Date: November 9, 1998  
 Refer to: EM/ER:98-442

**SUBJECT: RESONSE TO SEPTEMBER 18, 1998, LETTER FROM HRMB AND  
 SUBSEQUENT MEETING REGARDING THE REQUIREMENT FOR A  
 CLASS 2 MODIFICATION FOR THE POTENTIAL OPERATIONAL  
 DEVIATIONS FROM THE MDA-P CLOSURE PLAN**

**Enclosure 1**  
**Response to Technical Issues**

# Process Flow for Soils

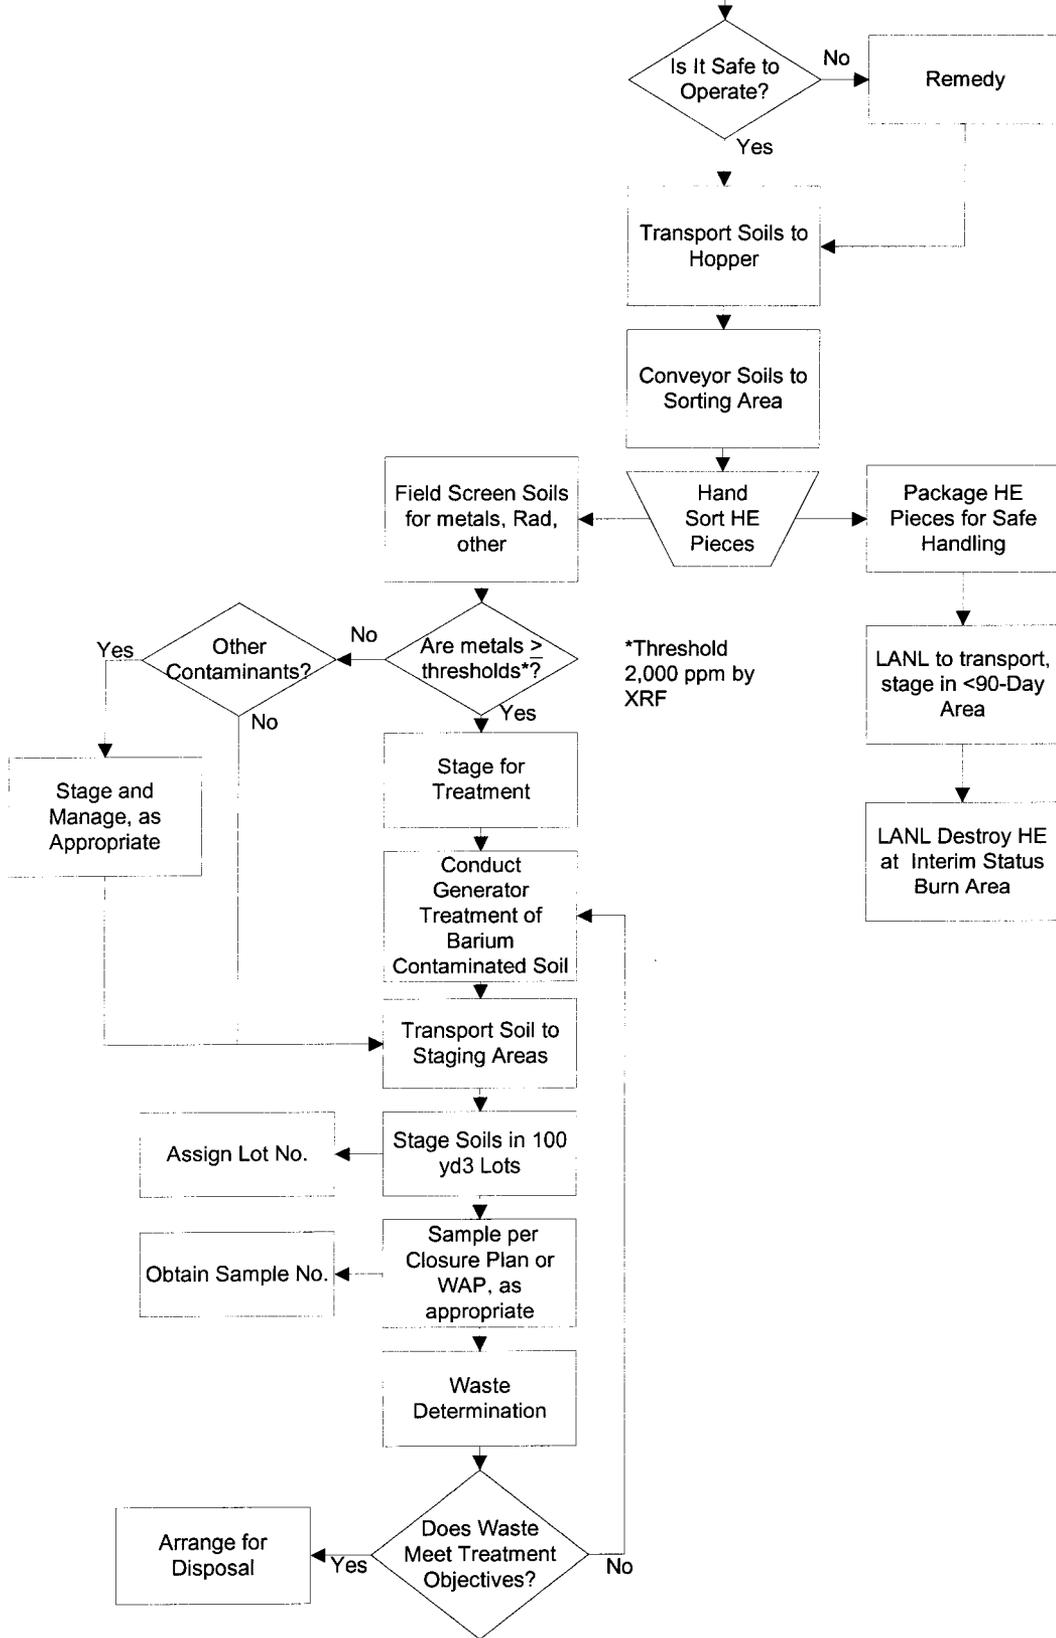
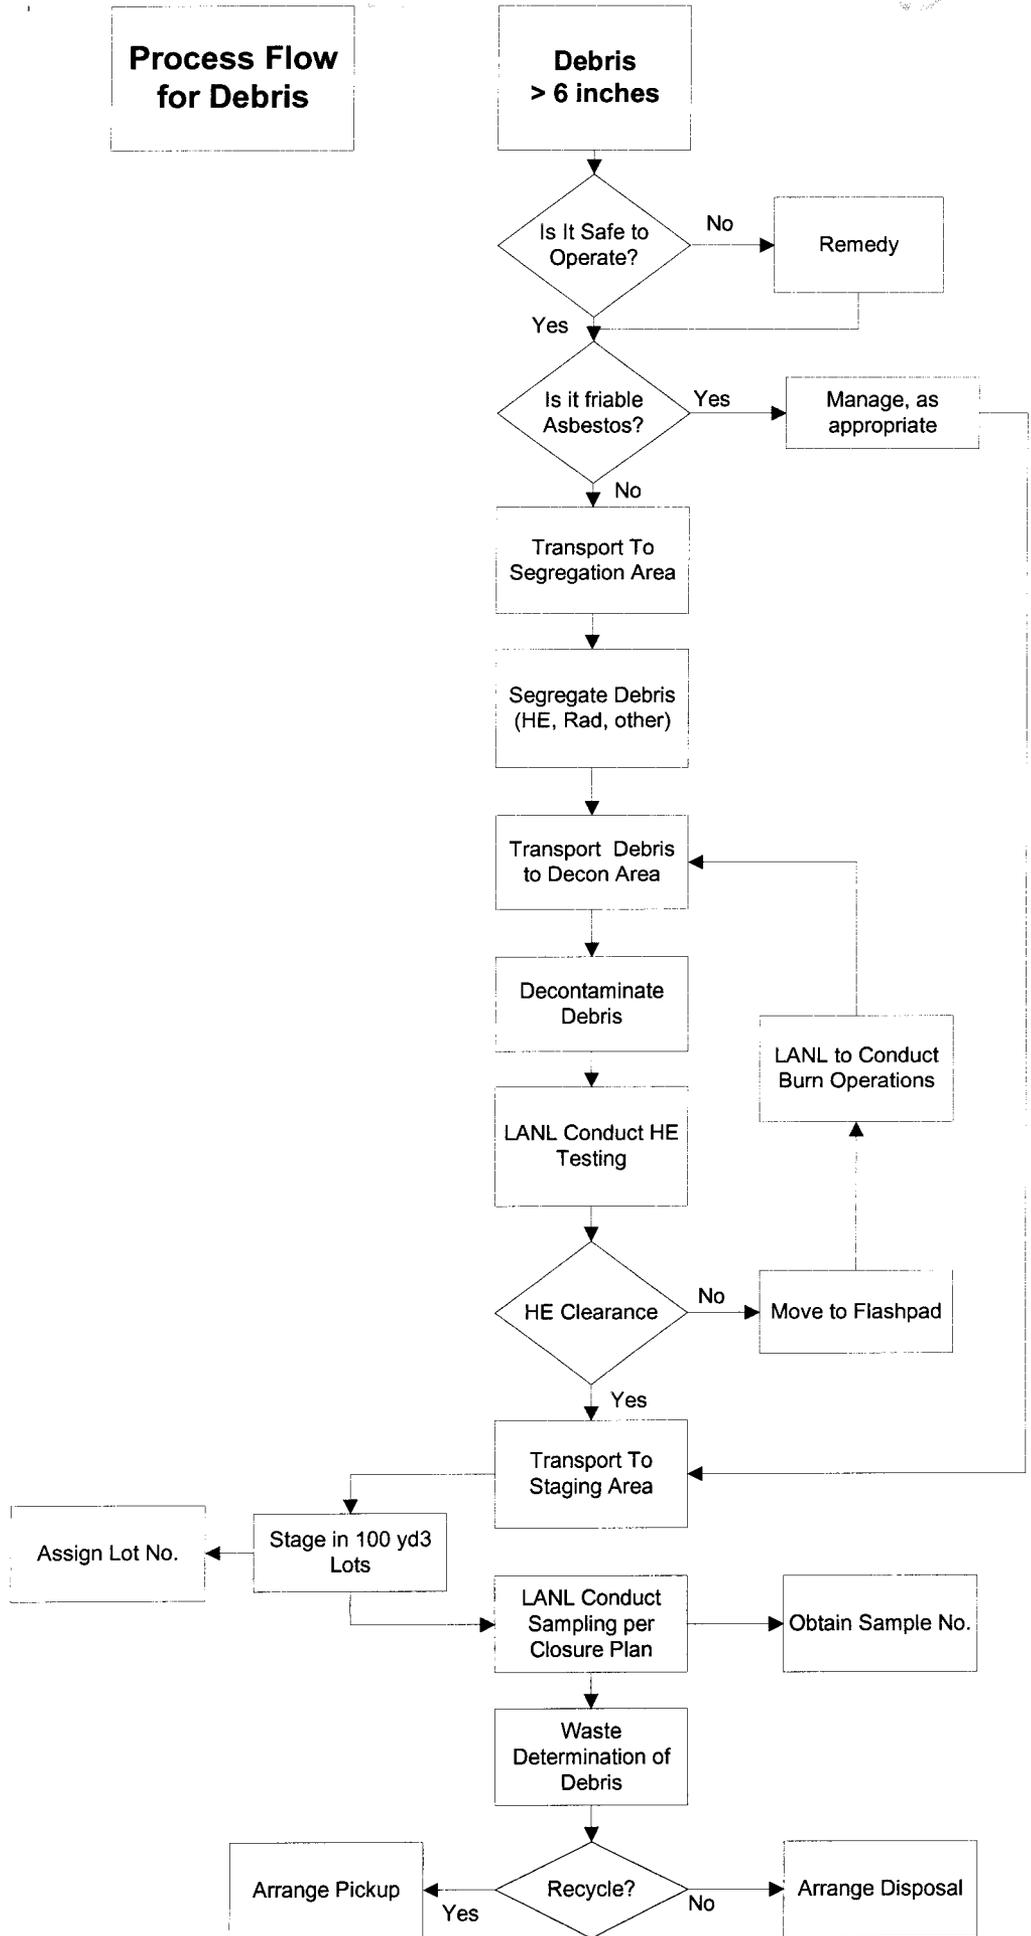
1. *All proposed changes to the closure plan to include high explosive (HE) handling processes shall be clarified using process flow diagrams and narrative summaries that illustrate and describe all waste streams and their ultimate disposal.*

Although process flow diagrams of waste management operations were not required in the approved Closure Plan, the following are included as Enclosure 2 for your information.

- Excavation Process Flow
- Process Flow for Soils
- Process Flow for Debris

SITE LAYOUT - AS-BUILT  
 CLEAN CLOSURE MDA-P

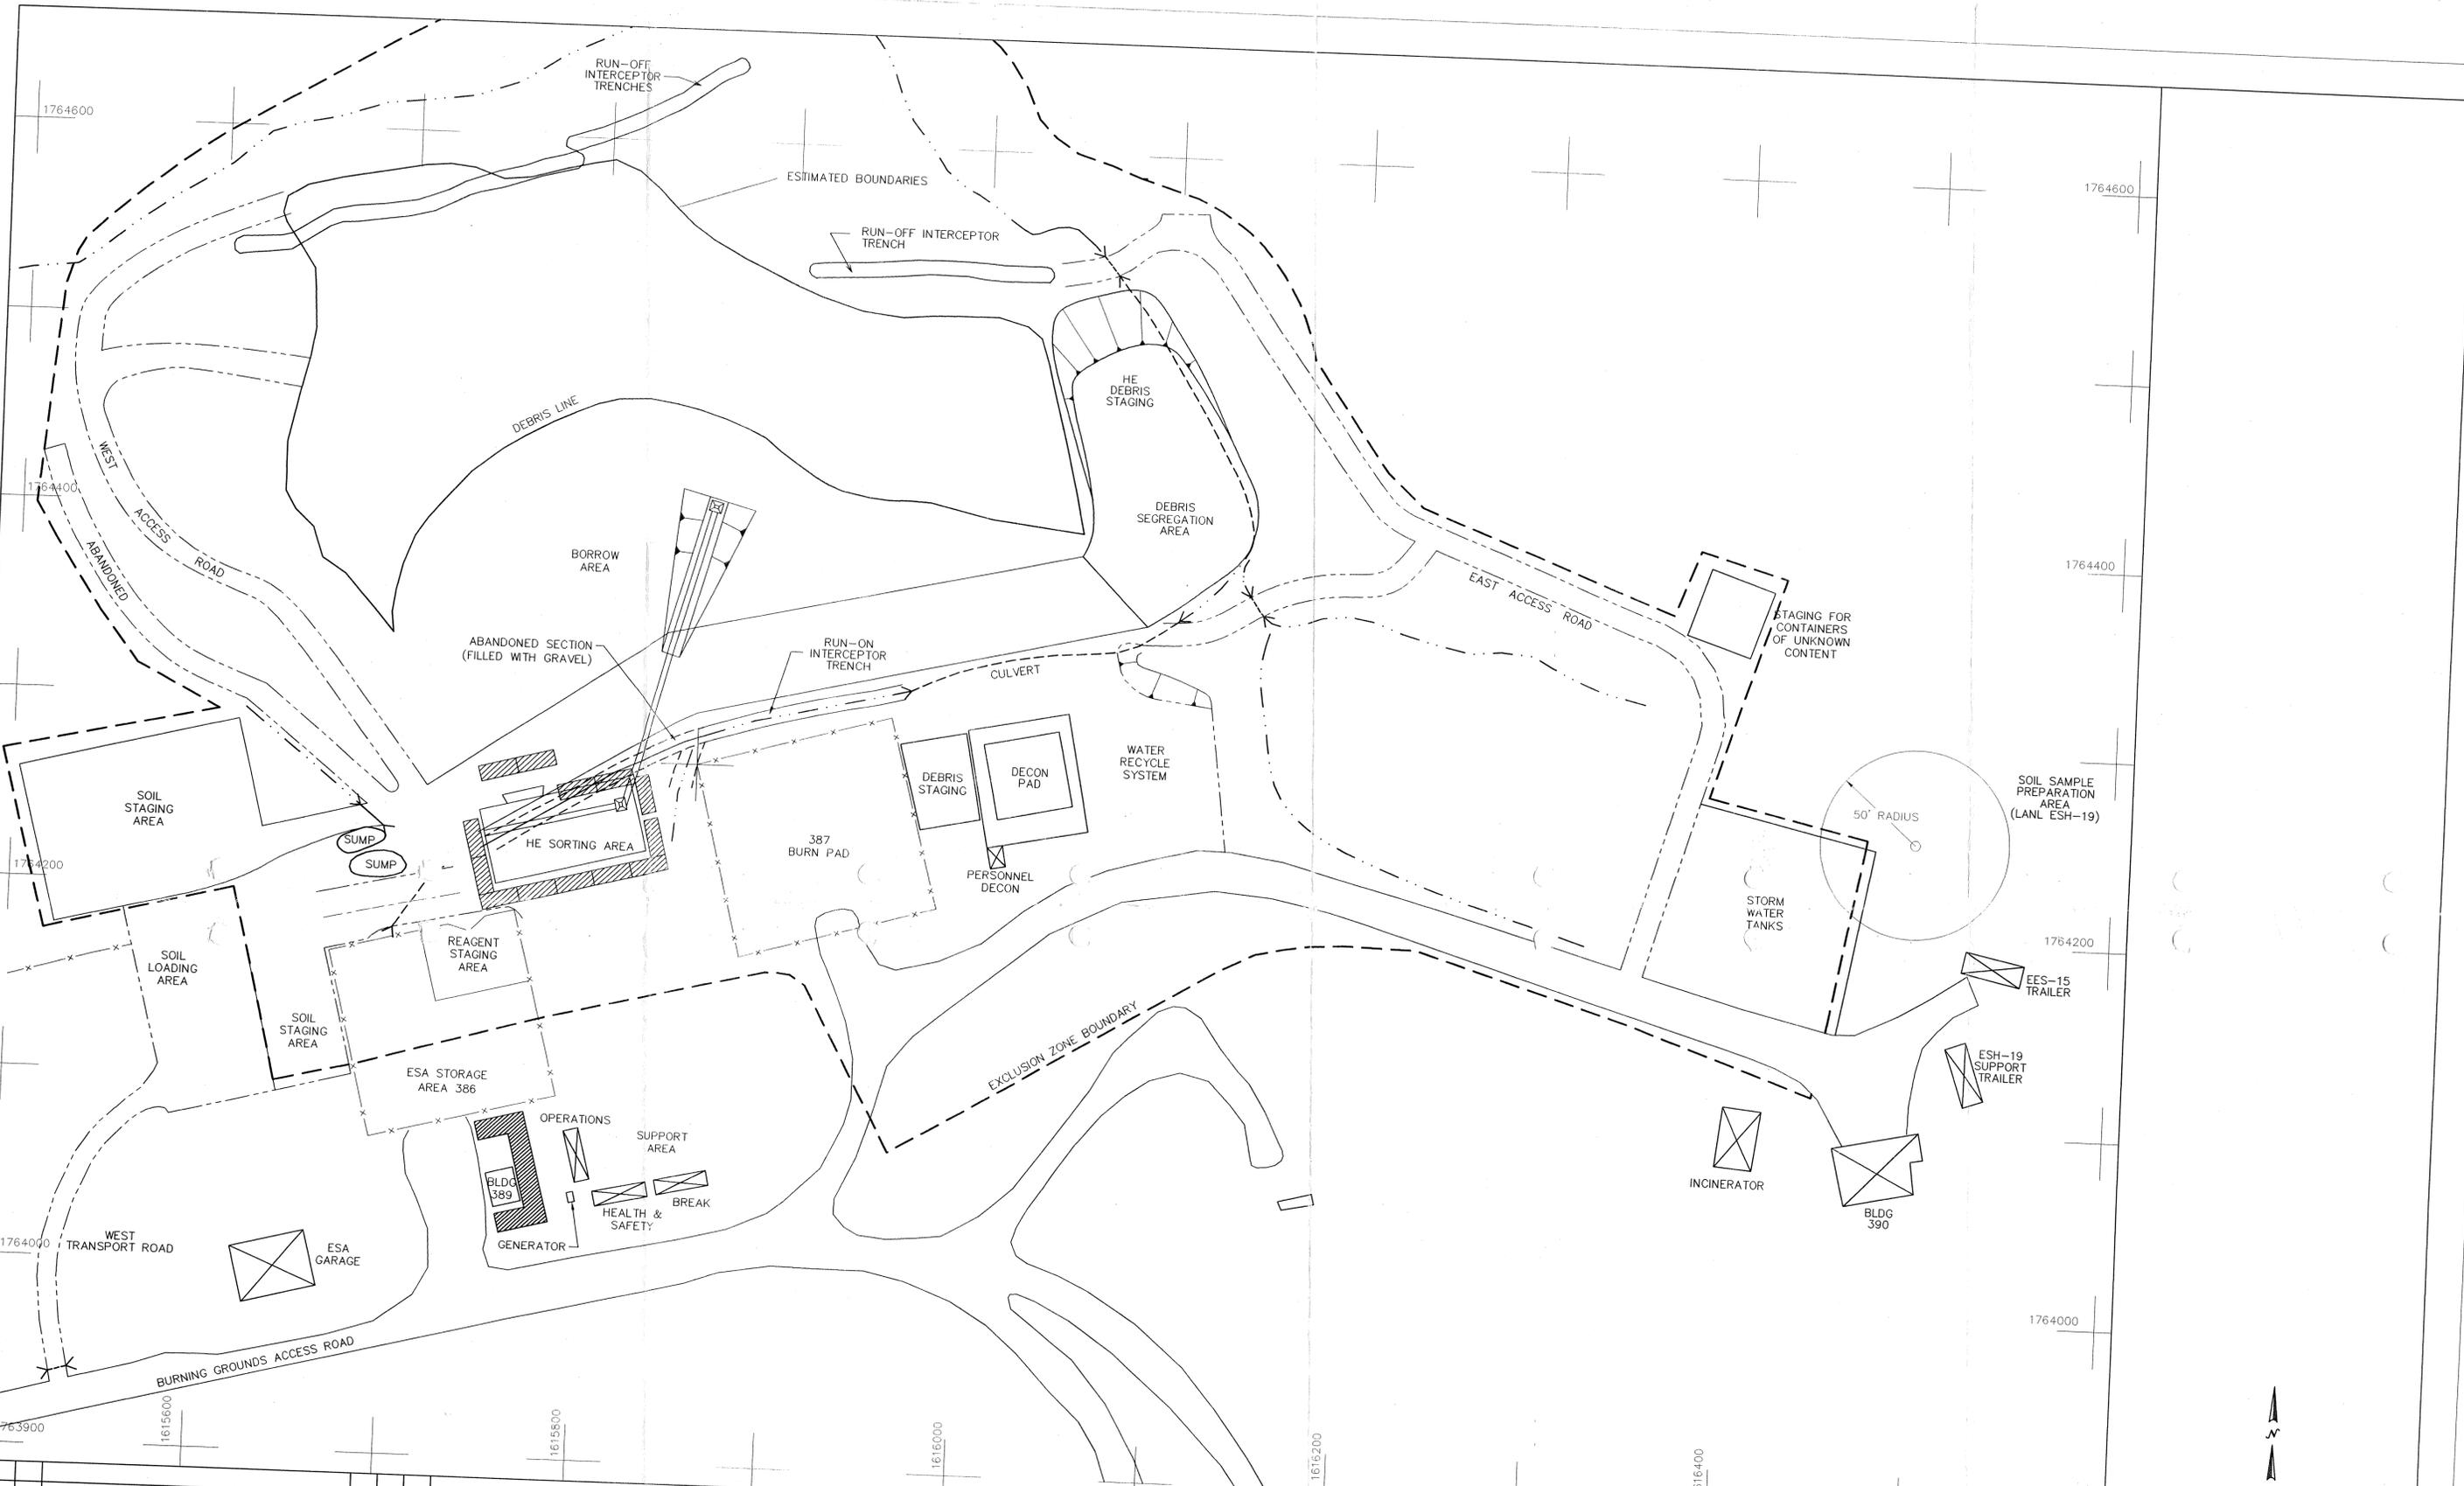
3. *The filtration system and sorting pad shall meet the requirements for temporary units as defined in 20 NMAC 4.1, 40 CFR 264.553-temporary units, and 40 CFR 270.42 Appendix I.D.3.e-requirements for a Class 2 permit modification.*

The sorting pad is contained within the AOC at MDA-P and is shown in the map provided as Enclosure 3. The Laboratory believes that the process of segregating pieces of HE from soil excavated at MDA-P clearly does not constitute treatment because it does not alter the chemical or physical characteristics of the waste streams generated (e.g., detonable pieces of HE retain their chemical and physical composition and contaminated soil retains its chemical and physical composition). These waste streams must be segregated because they are subject to different treatment standards and will be managed at different facilities. Environmental Protection Agency (EPA) policy allows repositioning of waste within the AOC without being considered newly generated and thus, the waste is not regulated as stored hazardous waste. In addition, Section 6.2.4 of the approved Closure Plan allows for segregation of waste materials. The excavation process flow diagram is provided in Enclosure 2. The Laboratory will not be operating a temporary unit to treat or store hazardous remediation waste and so a class 2 modification to the approved Closure Plan is not needed.
